NEWMAR CORP P.O. Box 30, Nappanee, IN. 46550 Title block--1-5TB	Model: DRESSER S-0 (SEE INDEX)	Sheet 1 OF 1	Drawn by: N. G.	Checked by: M. W.	Revision: UPDATED SHAFT COMPONENTS & LOCATIONS PER PRODUCTION (PCR #121484)	By: B. G.
	Title: DRIVE SHAFT ASSEMBLY	I.D. # 2012\HE\SO\PARTS\DR_SO_SHAFT_RBED	Date: 3/3/11	Date: 3/3/11	Revision:	Date: 8/10/11
						By: Date:

NEWMAR CORP P.O. Box 30, Nappanee, IN. 46550 Title block--75TB	Model: EX DP/KG DB	Sheet 1 OF 4	Drawn by: N. G.	Checked by: M. W.	Revision: REVISED FOR NEW ROOF MOUNTING PLATES. NEW PART #'S AND ROOF CONSTRUCTION PER ECO # 312	By: D. K. Date: 9/21/12
	Title: S-O MECHANICAL LOCK ARM SYSTEM COMPONENTS	I.D. # 2013\HE\SO\PARTS\EX-KG_TYP	Date: 11/17/11	Date: 12/1/11	Revision: ADDED PART # 120440 FOR ALTERNATE COLOR UHMW WALL PLATE (PCR #131294/ECO #173)	By: D. K. Date: 6/25/12

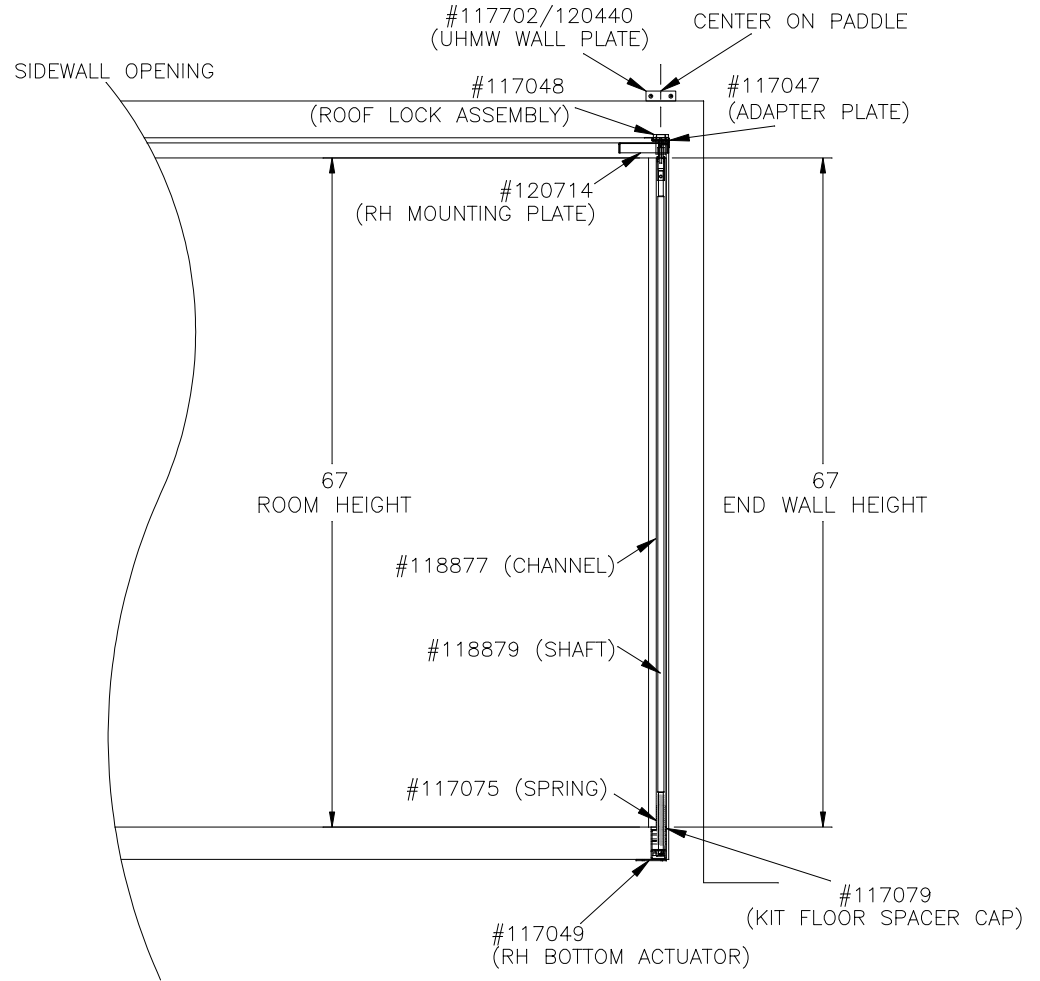
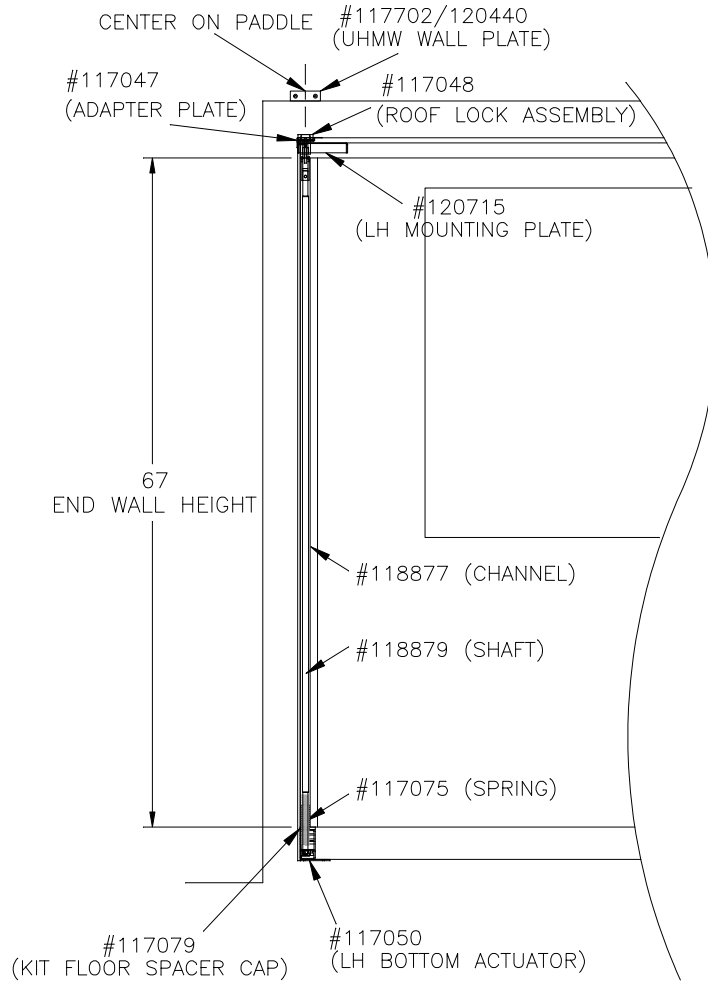
NEW BOTTOM ACTUATORS #119604 & #119605 ILO #117583 & #117584. N. G.
(2012 ECO #539) 2/14/12
REVISED LINE-UPS B. G.
2/9/12

NEWMAR CORP P.O. Box 30, Nappanee, IN. 46550 Title block--75TB	Model: EX DP/KG DB	Sheet 2 OF 4	Drawn by: N. G.	Checked by: M. W.	Revision: REVISED FOR NEW ROOF MOUNTING PLATES. NEW PART #'S AND ROOF CONSTRUCTION PER ECO # 312	By: D. K. Date: 9/21/12
	Title: S-O MECHANICAL LOCK ARM SYSTEM COMPONENTS	I.D. # 2013\HE\SO\PARTS\EX-KG_TYP	Date: 11/17/11	Date: 12/1/11	Revision: ADDED PART # 120440 FOR ALTERNATE COLOR UHMW WALL PLATE (PCR #131294/ECO #173)	By: D. K. Date: 6/25/12
	REVISED LINE--UPS					By: D. K. Date: 6/25/12

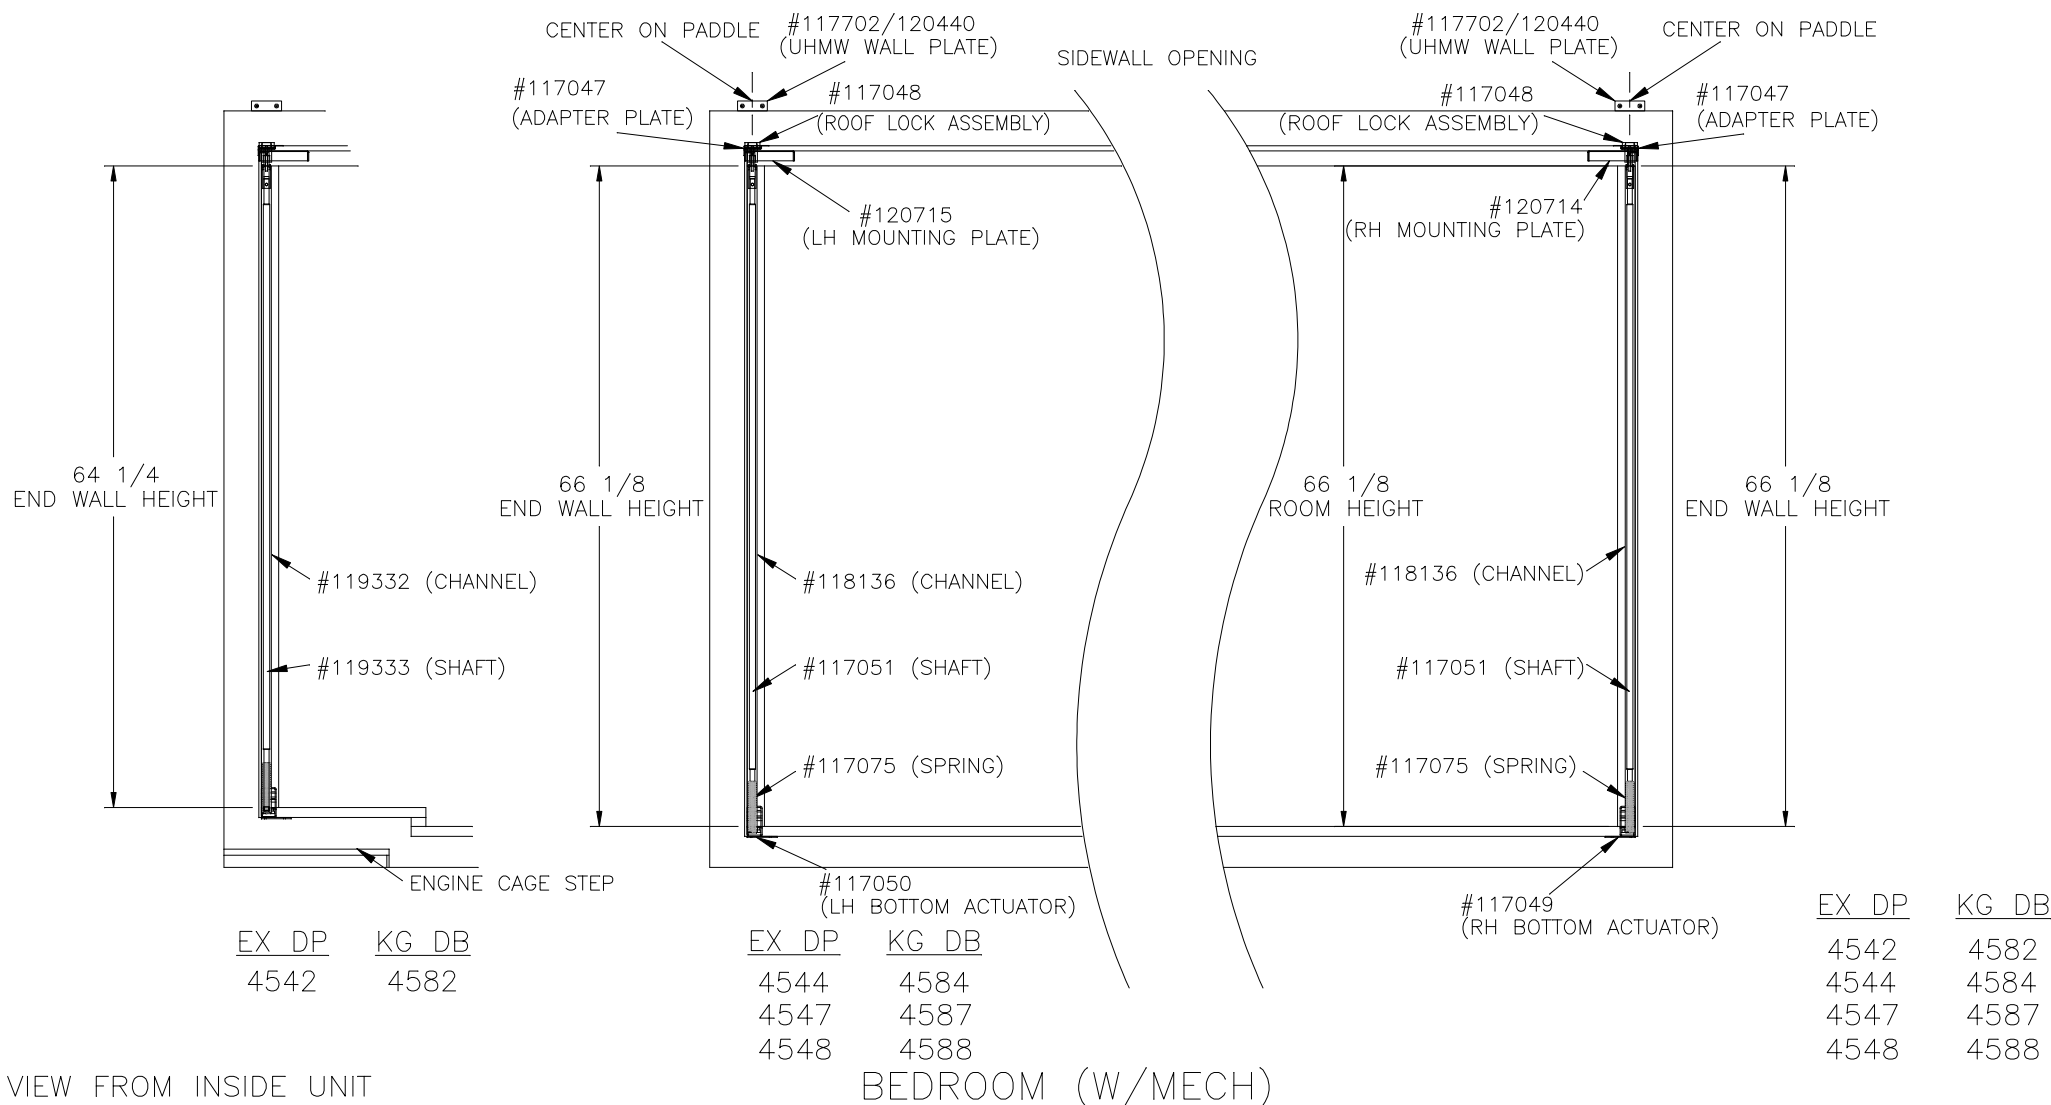
NEWMAR CORP P.O. Box 30, Nappanee, IN. 46550 Title block--75TB	Model:	Sheet	Drawn by:	Checked by:	Revision:	By:
	EX DP/KG DB	3 OF 4	N. G.	M. W.	REVISED FOR NEW ROOF MOUNTING PLATES. NEW PART #'S AND ROOF CONSTRUCTION PER ECO # 312	D. K.
	Title: S-O MECHANICAL LOCK ARM SYSTEM COMPONENTS	I.D. # 2013\HE\SO\PARTS\EX-KG_TYP	Date:	Date:	Revision: ADDED PART # 120440 FOR ALTERNATE COLOR UHMW WALL PLATE (PCR #131294/ECO #173)	Date: 9/21/12
			11/17/11	12/1/11		Date: 6/25/12

NEW PART NUMBERS FOR 64 1/4 END WALL HEIGHT CHANNEL & SHAFT.

64 1/4" END WALL HEIGHT OVER ENGINE CAGE STEP ILO 64 1/8".

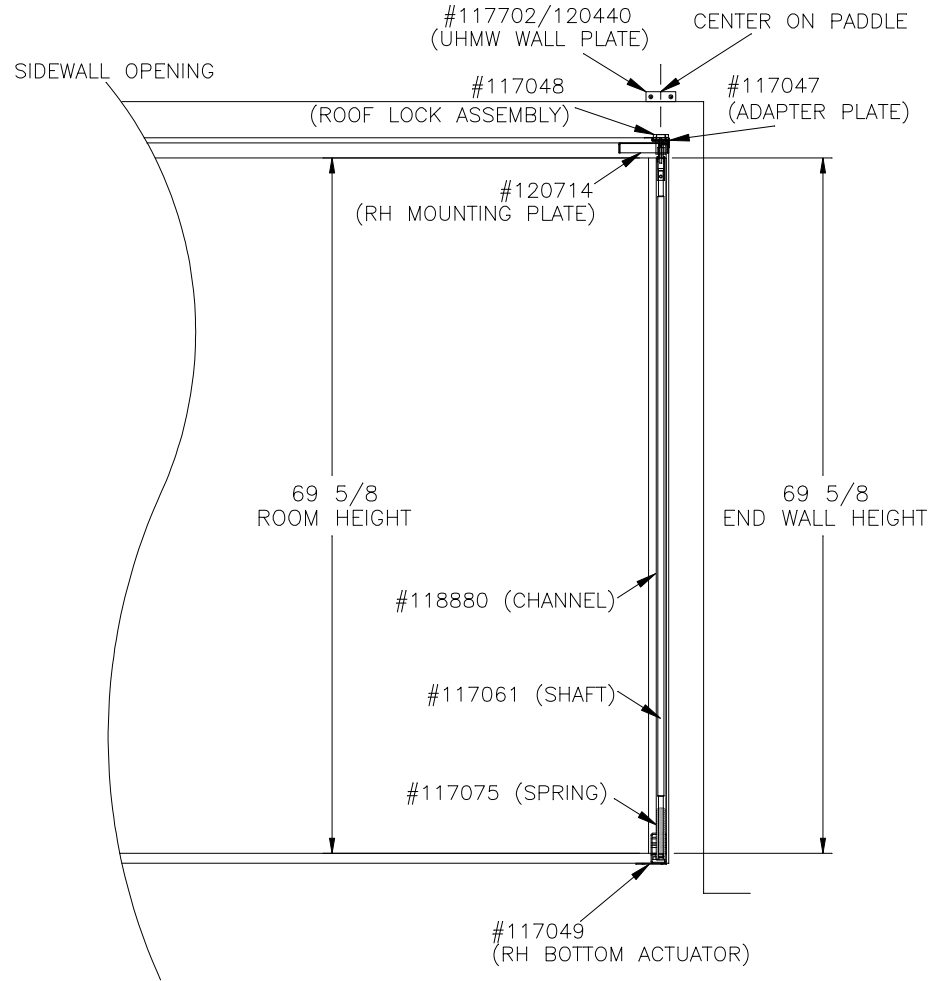
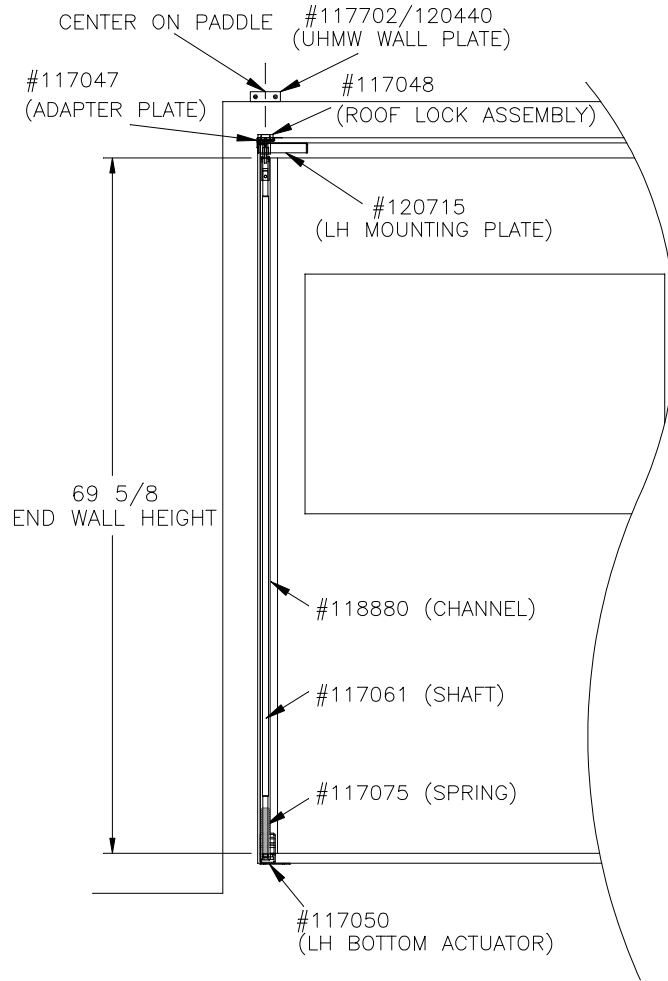
NEWMAR CORP P.O. Box 30, Nappanee, IN. 46550 Title block--75TB	Model: EX DP/KG DB	Sheet 4 OF 4	Drawn by: N. G.	Checked by: M. W.	Revision: REVISED FOR NEW ROOF MOUNTING PLATES. NEW PART #'S AND ROOF CONSTRUCTION PER ECO # 312	By: D. K. Date: 9/21/12
	Title: S-O MECHANICAL LOCK ARM SYSTEM COMPONENTS	I.D. # 2013\HE\S0\PARTS\EX-KG_TYP	Date: 11/17/11	Date: 12/1/11	Revision: ADDED PART # 120440 FOR ALTERNATE COLOR UHMW WALL PLATE (PCR #131294/ECO #173)	By: D. K. Date: 6/25/12

REVISED LINE-UPS
